RHODE ISLAND CONTRACT NO.2016-CB-059

0009N WASHINGTON BRIDGE NORTH NO 700 (57A T-J)

NOTICE TO PROSPECTIVE BIDDERS

ADDENDUM NO. 2 Prospective bidders and all concerned are hereby notified of the following changes in the Plans, Specifications, Proposal and Distribution of Quantities for this contract. These changes shall be incorporated in the Plans, Specifications, Proposal and Distribution of Quantities, and shall become an integral part of the Contract Documents.

| | | | DROP IN SPAN TEMP. SUPPORT AND JACKING SHEET 1 | |

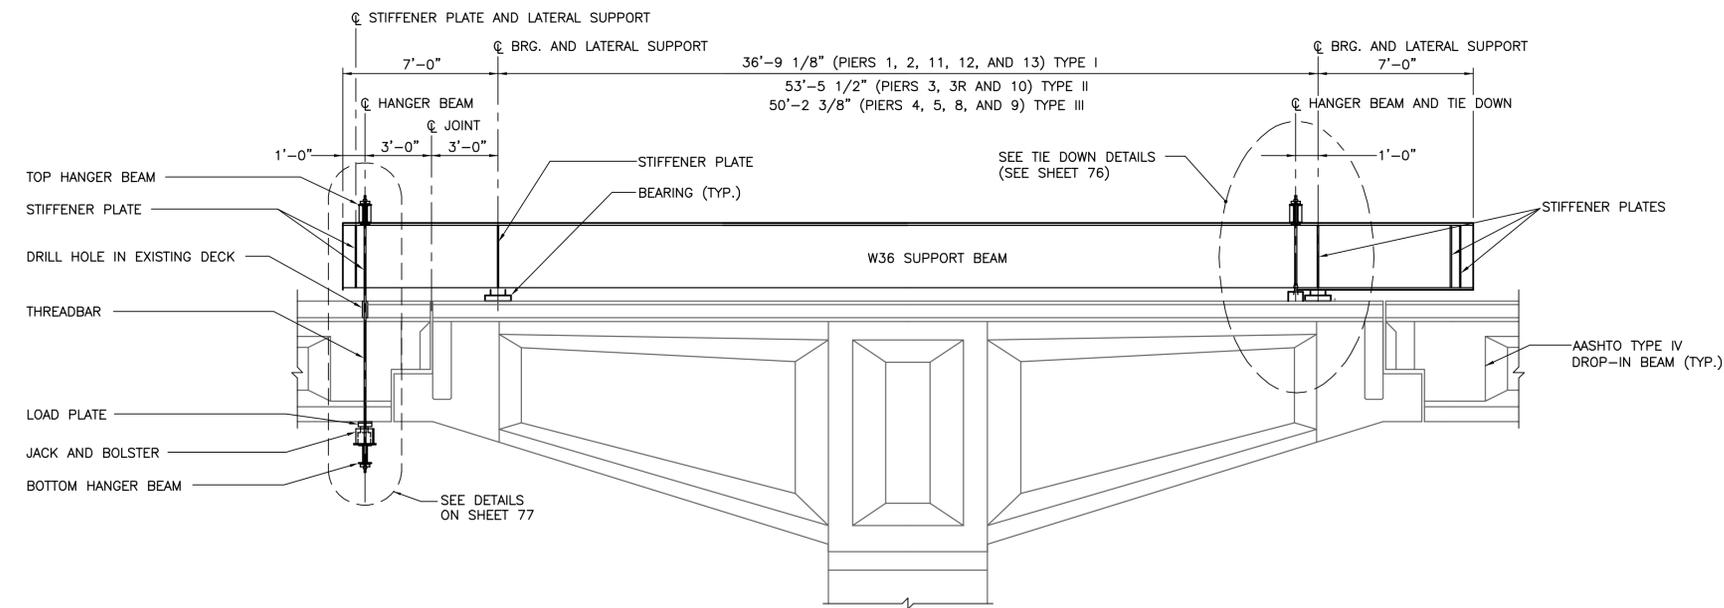
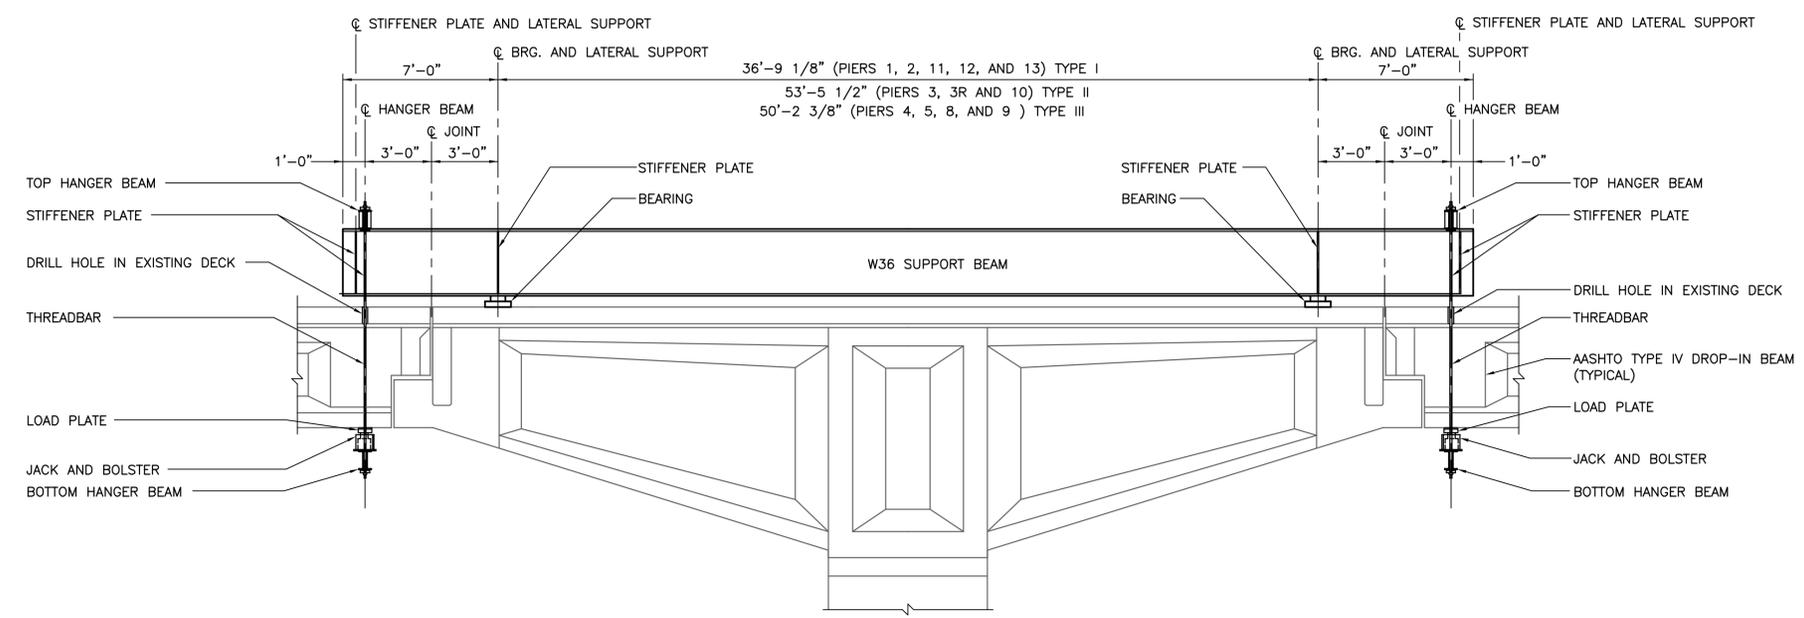
3.6 Sheet 72 - Drop In Span Temp. Support And Jacking Sheet 1 - Note 1 has been added.

| REVISIONS | | | RHODE ISLAND | |
|-----------|---------|----|---|------------------------|
| | | | DROP IN SPAN TEMP. SUPPORT AND JACKING SHEET 4 | |

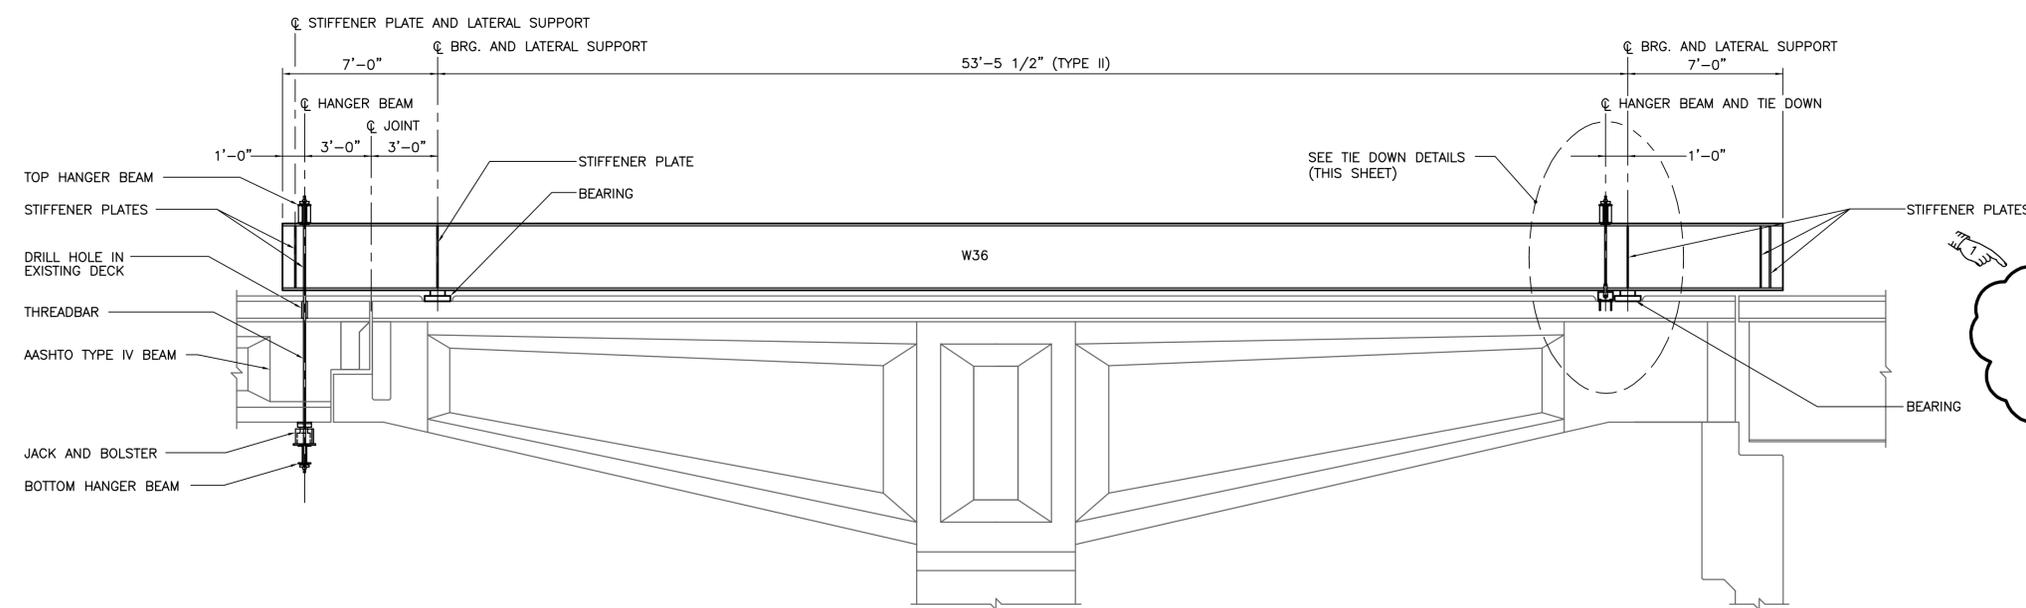
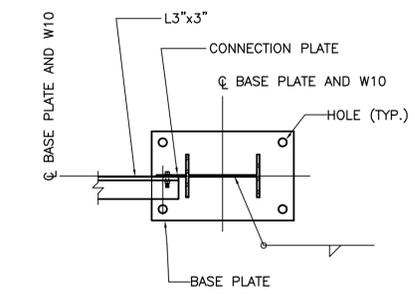
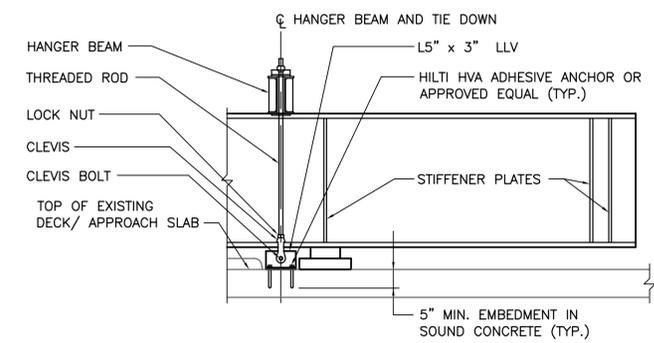
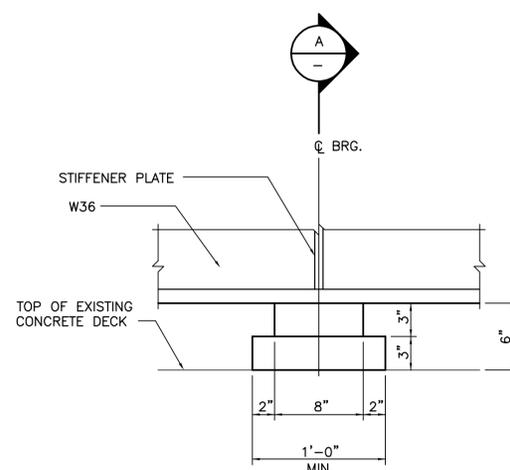
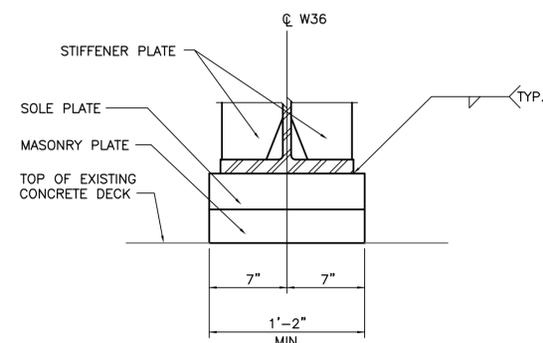
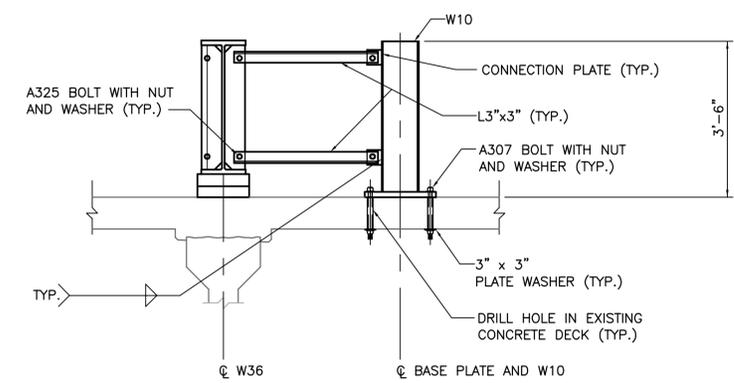
3.7 Sheets 75, 76, 77 - Drop In Span Temp. Support And Jacking Sheets 4 thru 6 - Clarification note has been added to the sheets indicating details shown are conceptual in nature.

JACKING DETAILS SHOWN ARE INTENDED TO BE CONCEPTUAL. CONTRACTOR IS RESPONSIBLE FOR SUBMITTING JACKING DESIGN AND DRAWINGS IN ACCORANCE WITH SPECIAL PROVISION 800.9901.
